City of Highland Park NATURAL RESOURCES COMMISSION

Wednesday, June 8, 2016
Highland Park City Hall
1707 St. Johns Avenue
Highland Park, Illinois
6:30 p.m.

To: Members of the Natural Resources Commission
From: Eric Olson, Planner II
Date: June 6, 2016
Re: 116 Deere Park Court– Steep Slope Variation Request

SUBJECT: 116 Deere Park Drive, Proposed Deck Expansion in the Steep Slope Zone

1 PROPOSED SITE PLAN (W/SURVEY OVERLAY)
1/8" = 1'-0"

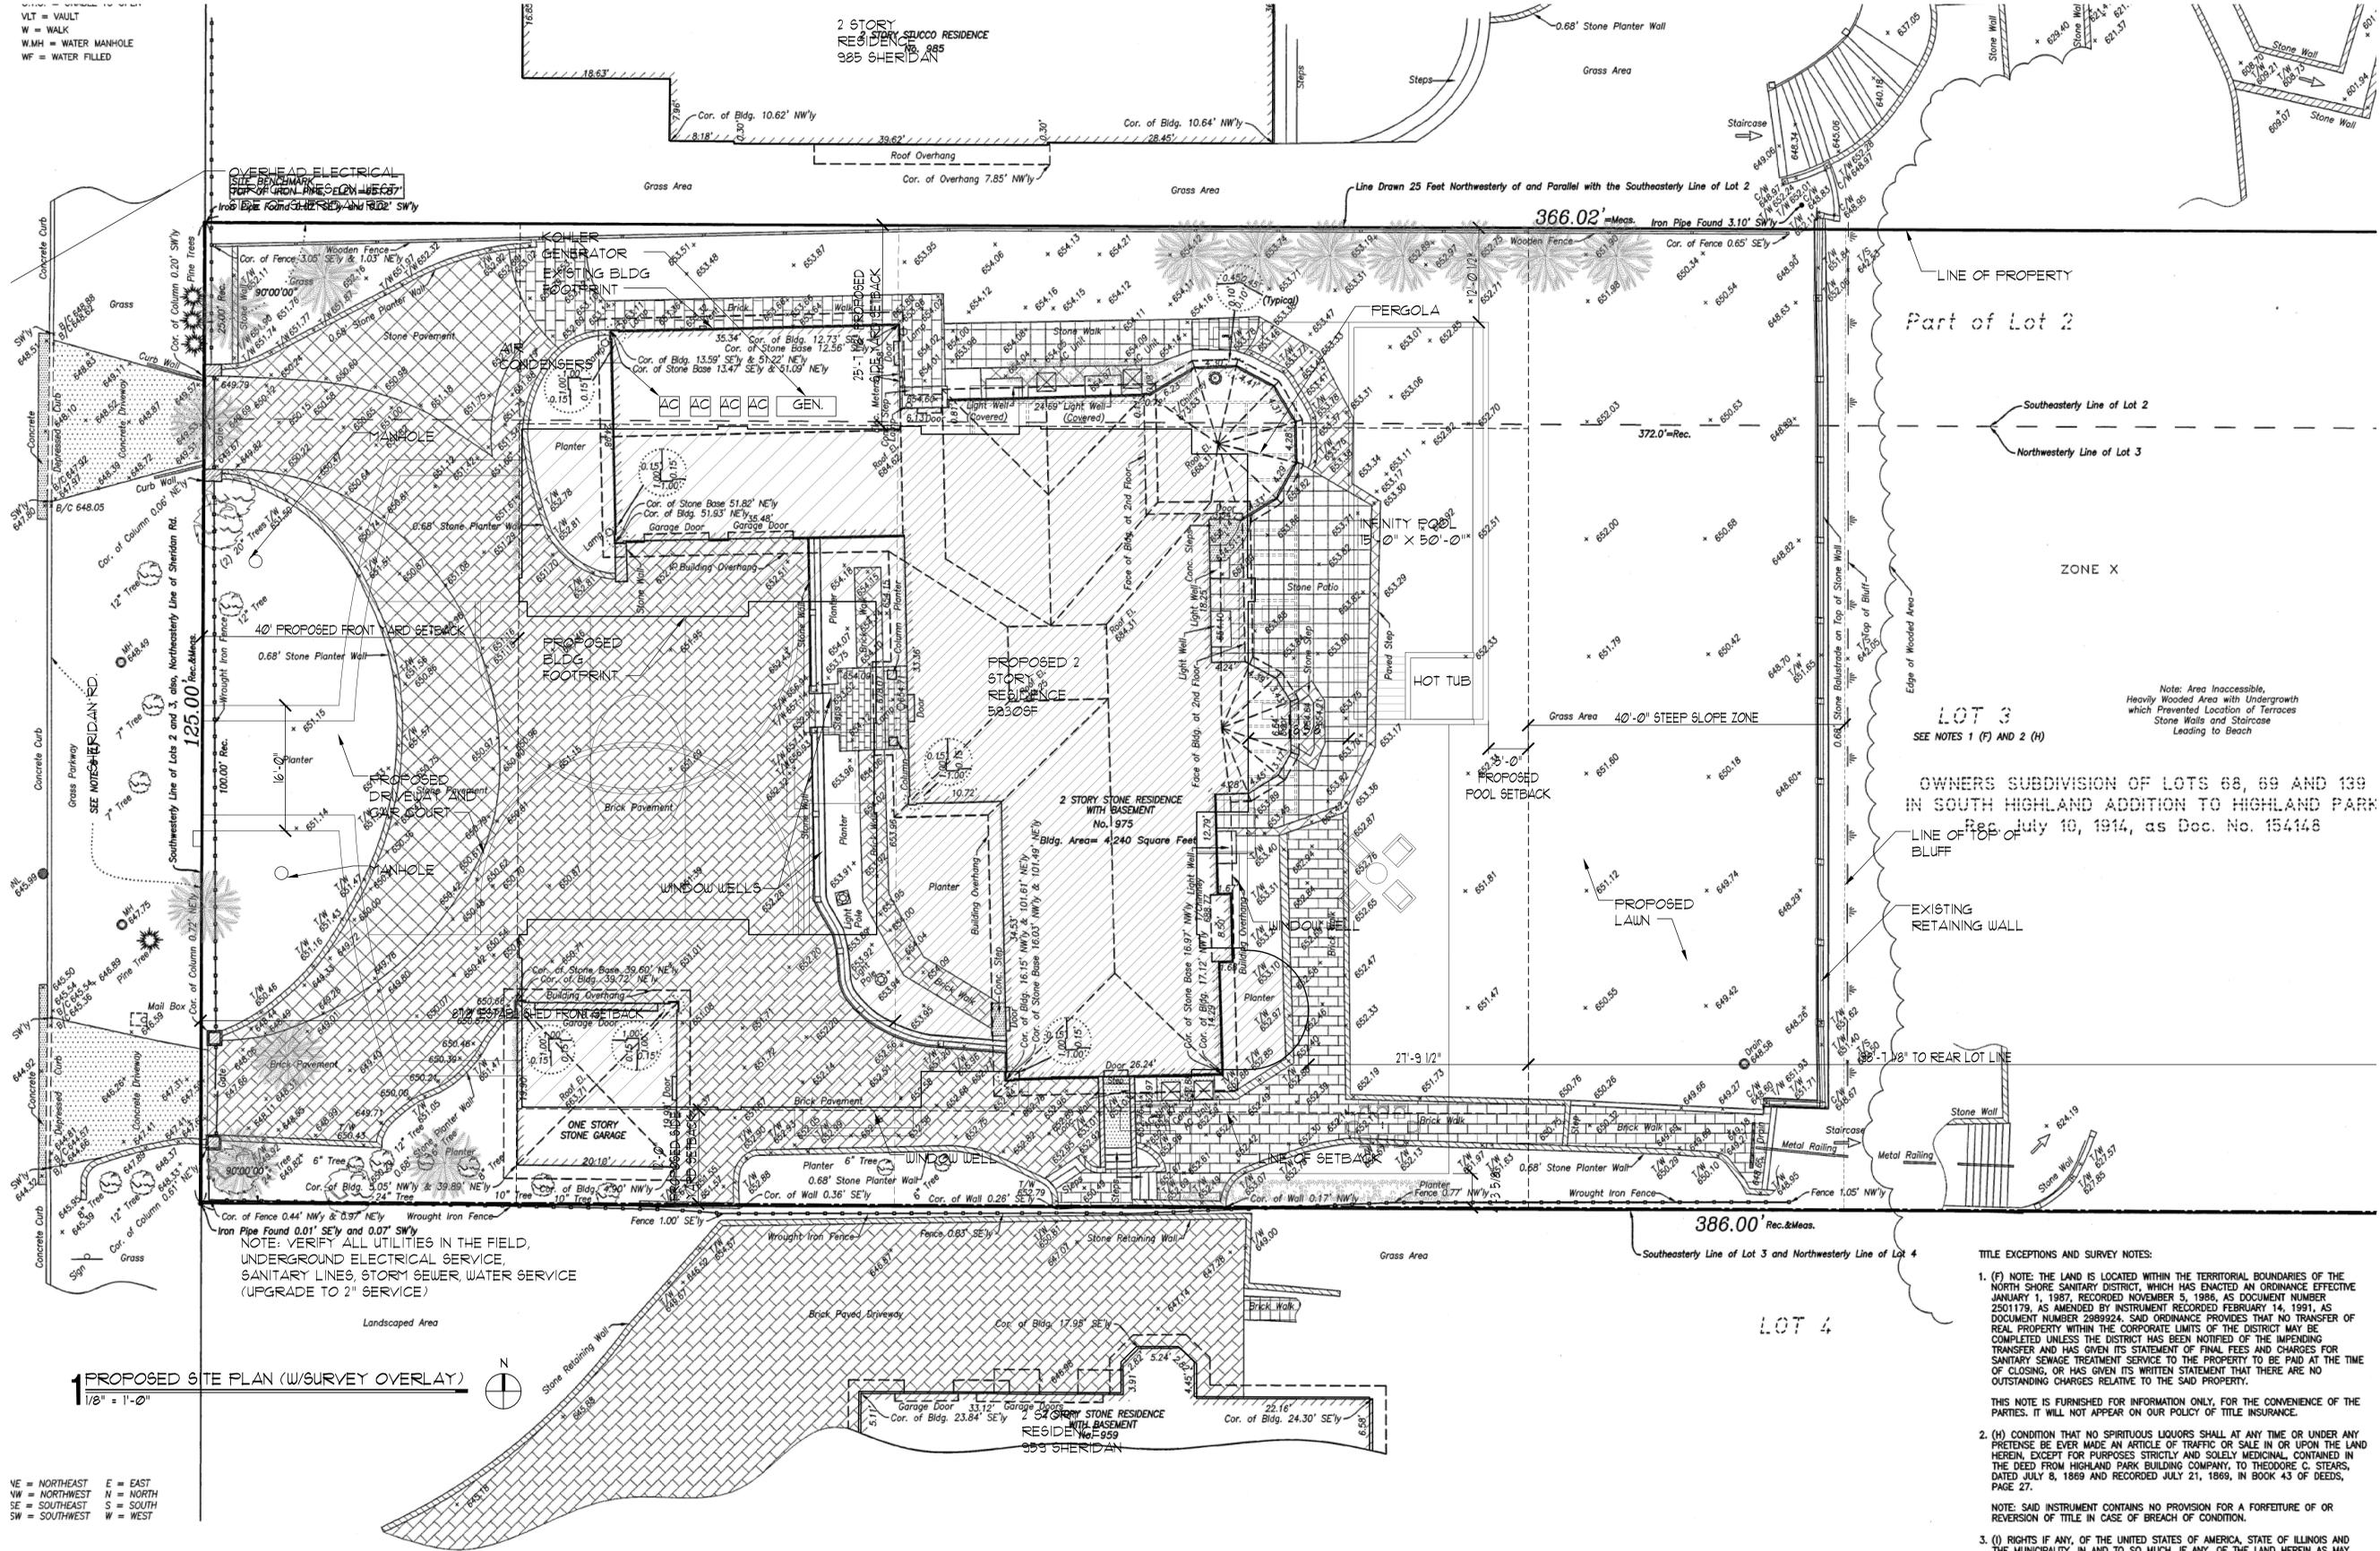
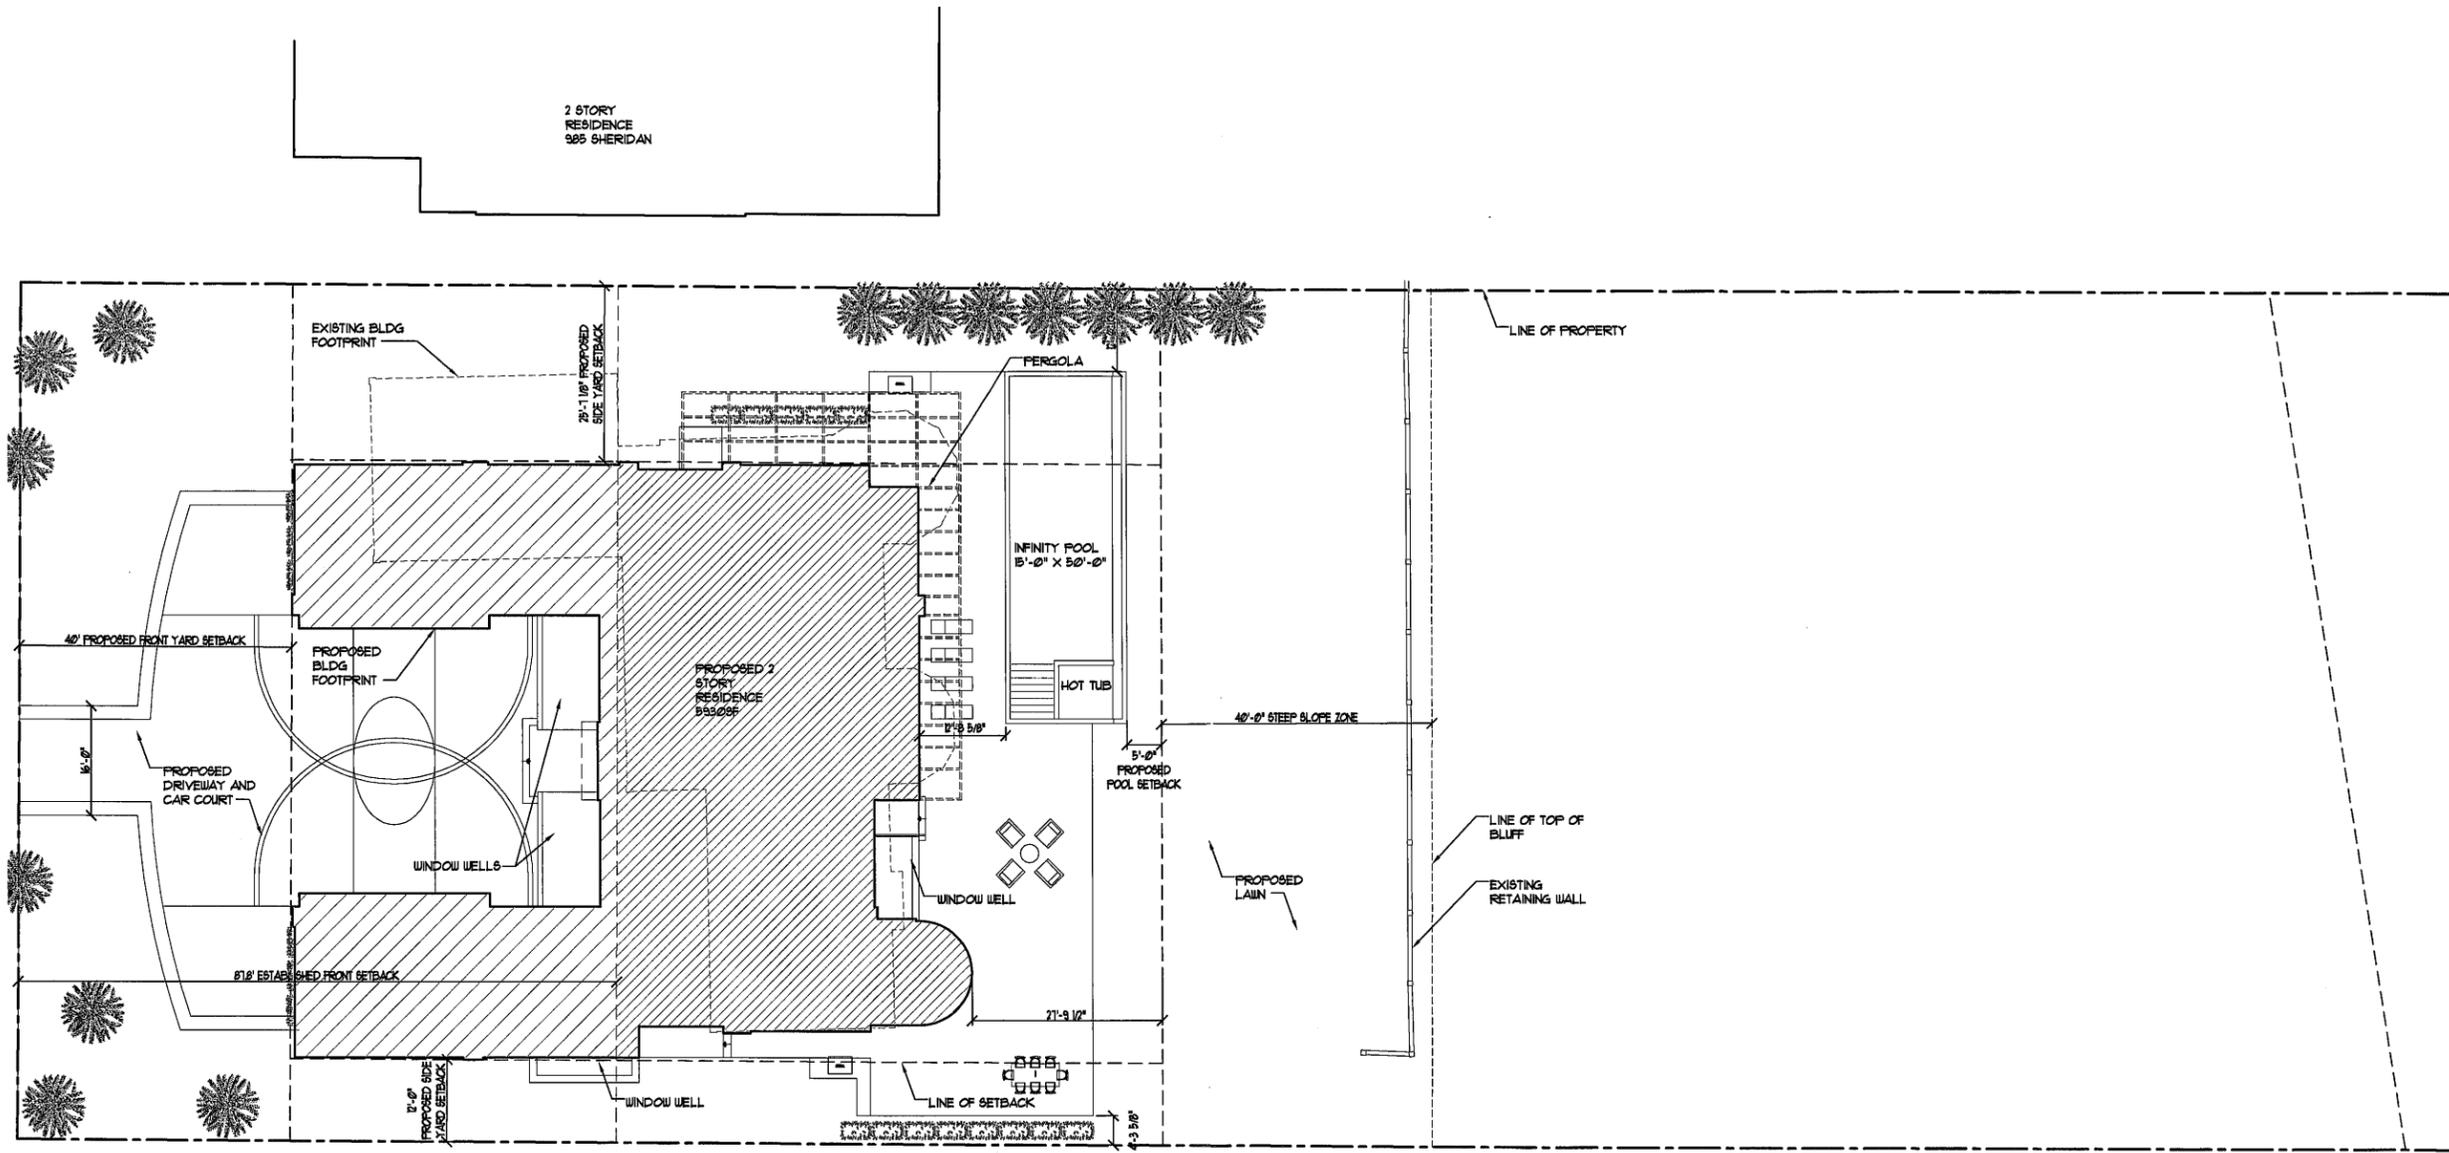
An applicant is proposing to construct a new 9,992 square foot single family residence at 975 Sheridan Road (*refer to image above*). As part of the proposed construction, the applicants intend to build an “infinity pool”-style underground swimming pool. However, as currently sited the proposed swimming pool encroaches five feet into the 10’ special setback for swimming pools that are in addition to the 40’ lake bluff setback from the top of the Steep Slope, as defined by Article 19 of the Zoning Code.

Recognizing the existing topography and vegetation, the pool is sited on a flat piece of land with no trees or vegetation other than sod in the rear yard, part of which is currently an impervious stone patio (See attached overlay site plan). The proposed pool is only a 5 foot deep lap pool, 15 feet by 50 feet oriented North-South (parallel with the bluff line). The additional 10 foot setback for pools is likely due to the construction process of digging down means the angle of repose will extend beyond the edge of the pool at a 45 degree angle from the bottom of the excavation. Since we are only digging down 5 feet, the earth to the east of the pool would only need to be disturbed +/-5 feet past the edge of the pool, which would still not encroach into the 40 foot steep slope zone, where no structures are allowed. Aside from a walkway to the stairs at the retaining wall, there will be nothing but plantings and sod in the steep slope zone. Furthermore, this existing retaining wall works to stabilize the bluff line and reduces concerns for soil slippage/instability.

In order to reduce the amount of impervious surfaces to be placed on table land adjacent to steep slopes, the proposed rear yard terrace will be sand set bluestone pavers. The proposed site plan has more planting and sod than the existing house; much of the existing impervious surfaces will be removed as part of the project. Additionally, we seek to enhance the landscape and vegetation by planting new trees to the north of the pool. These root structures will help to stabilize the bluff.

As requested by Morgante Wilson Architects, Soil and Material Consultants, Inc. has reviewed the proposed site plan for the Shapiro Residence located at 975 Sheridan Road in Highland Park, Illinois. The proposed site plan includes a 5 foot deep pool, 15 feet wide by 50 feet long which is situated parallel to the bluff and encroaches 5 feet into the steep slope zone. In our opinion construction of the pool at the proposed location will not have a negative impact on the stability of the bluff. The pool construction will reduce the weight on the bluff as the density of water is approximately one-half the weight of the soil it will be replacing.
